Version: B

Date: 16 February 2024

Engine draining. Drain valve of the turbine casing. Modification TF 92.

APPLICABLE ENGINE / VARIANT(S)	EFFECTIVITY CODE	Maintenance Level	CONDITION OF APPLICATION	EFFECT ON OPERATION
ARRIUS 2	244	1, 2, 3	Application if replacement of the drain valve	Removal/installation of the drain valve assembly
F, R	2-A-1	4	Application upon first return to an approved Repair Center

Figure 1

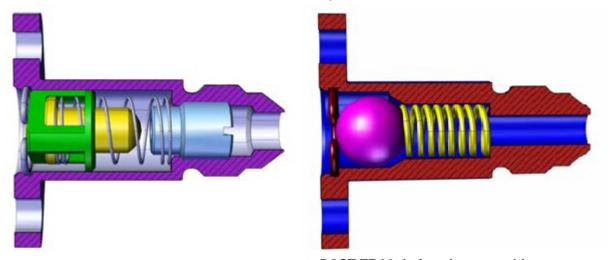
Modification TF 92 introduces a new drain valve assembly. The number of components is reduced, design is simplified and materials are chosen to get a better resistance to corrosion. The spring section is increased. A ball seals the valve body.

PRE TF 92 drain valve assembly

POST TF 92 drain valve assembly
